Re: Lonetree Reservoir Dam (CO 01734)  
W. Div. 1 W. Dist. 4

## SUMMARY OF ASSESSMENT AND RECOMMENDATIONS

# National Dam Safety Program Lonetree Dam

Final Report

PLATE 3 - APPENDIX C

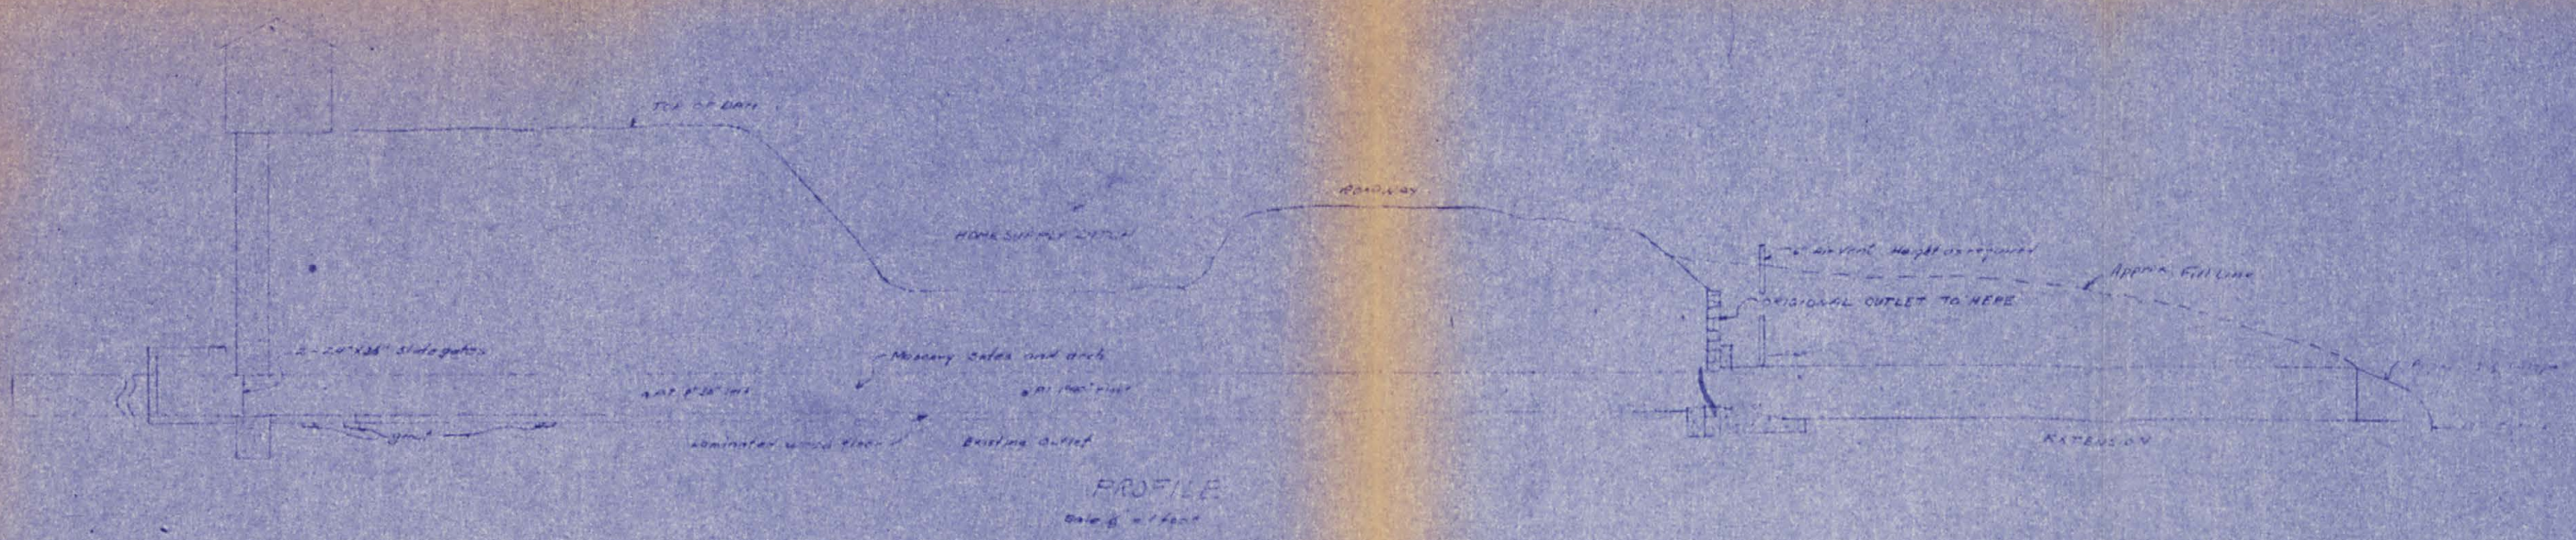
The outlet works for Lonetree Dam have operated satisfactorily for several years. However, some seepage was observed coming into the outlet conduit through the masonry (rock) lining at sections under the Home Supply Canal. There are no guard gates on the outlet works to facilitate repair and maintenance of the operating gates. Because there is no wasteway below the dam, the reservoir can only be evacuated by releasing water onto the farmlands served by the project.

- c. Monitor seepage into the masonry- (rock) lined outlet conduit with a full head of water in the Home Supply Canal and the reservoir extension channel.

- d. Install one or more piezometers on the downstream side of the crest of the dam above the outlet works to assist in detection of possible increases of seepage into or along the conduit.

PLAN AND PROFILE: STATION 25+00 TO 50+00, AND SPILLWAY DISCHARGE CURVE

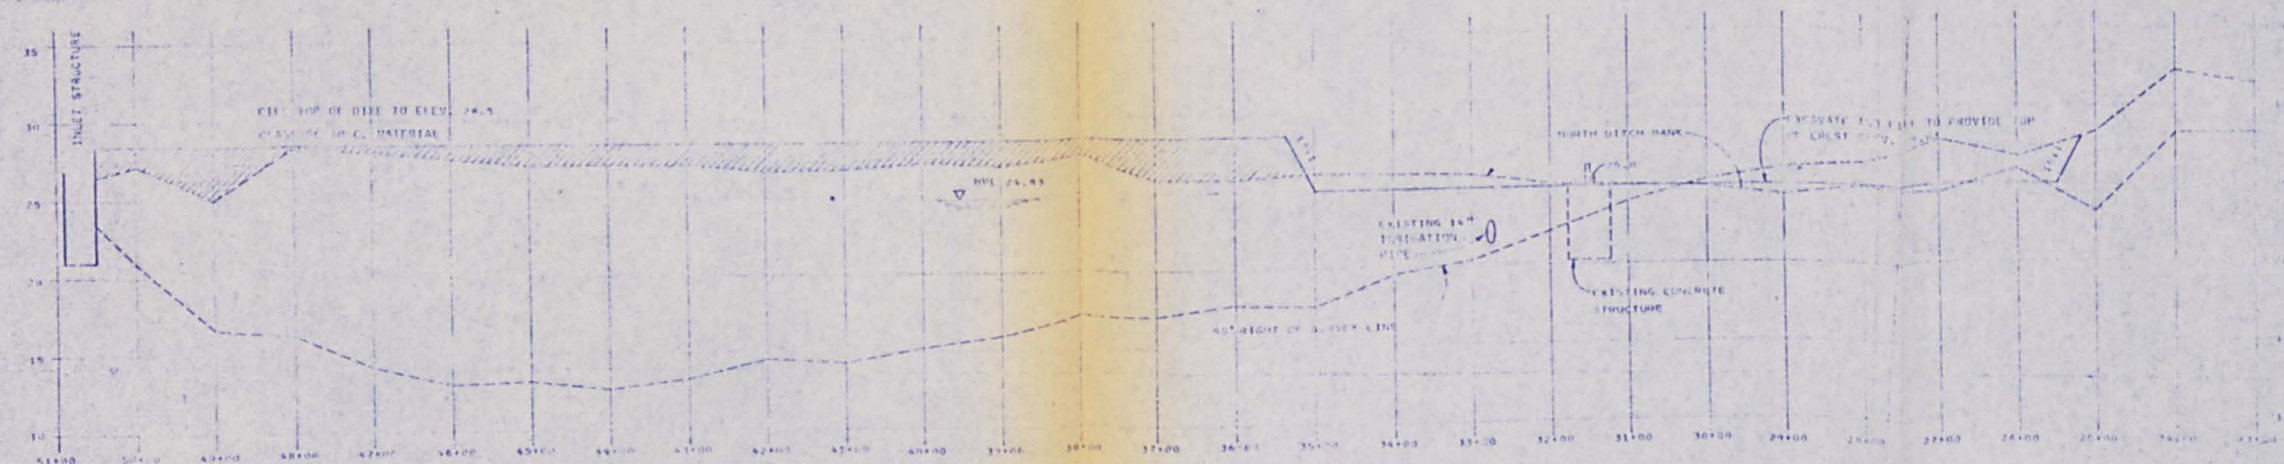
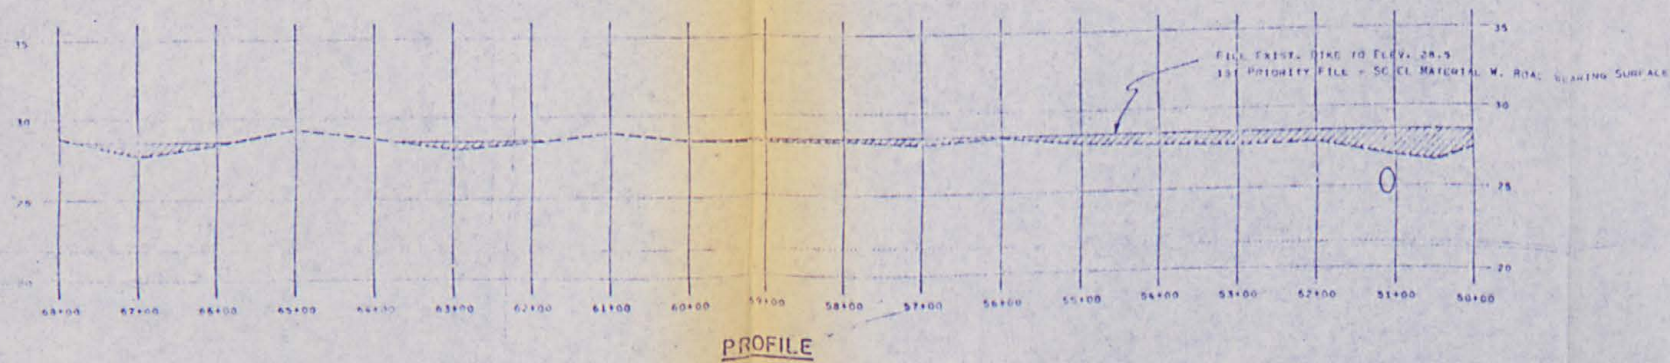
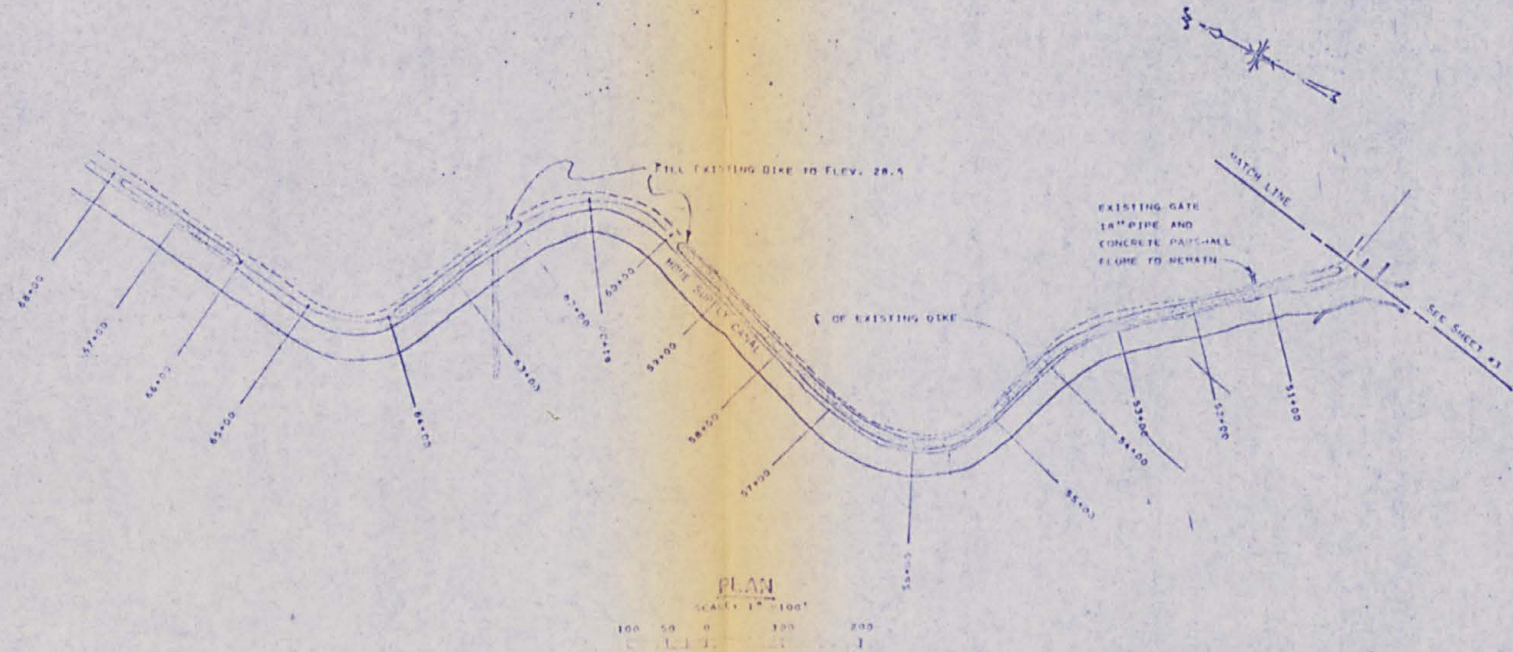
g. Spillway. Recent construction has provided a 950-foot-wide uncontrolled emergency spillway, shown in Photo No. 5, with a crest elevation of 25.0 (gage). As shown on Plate 5, Appendix C, the spillway crest is located on the dike between Station 25+50 and 35+00. If the reservoir rises above elevation 25.0 (gage) it would spill over the right bank of the Home Supply Canal, inundate the diversion structure at Station 31+50, flood the canal to the barrier at Station 0+70, then discharge over the spillway crest. Outflow exiting from the spillway crest would turn sharply to the left in a broad channel about 1100 feet long cut largely in sandstone rock. From the end of the constructed channel the flow would enter Ryan Gulch. After passing through Ryan Gulch Lake, shown in Photo No. 6, about three miles north of the spillway, the discharge would continue northward to the Big Thompson River. An inhabited farmhouse, shown in Photo No. 6, and several small buildings lie within the flood path and would be subjected to severe damage by a large spill.

a. The Emergency Spillway. Based on precipitation values in the National Weather Service's Technical Paper No. 38 and the Bureau of Reclamation "Design of Small Dams," 2nd Edition, the dam, spillway and dike can accommodate the probable maximum flood without overtopping the dam or dike. However, the earthen spillway weir would erode under a spill caused by such an event and release additional water to the flood plain below the dam. Water that might enter the Home Supply Canal during a flood would also add to this problem. Placing the canal in a siphon under the spillway sections, which has been suggested, would contain the canal flow but would not prevent release of water from the reservoir due to erosion of the crest. For this reason it is recommended that the earthen spillway weir be replaced with an erosion-resistant structure.
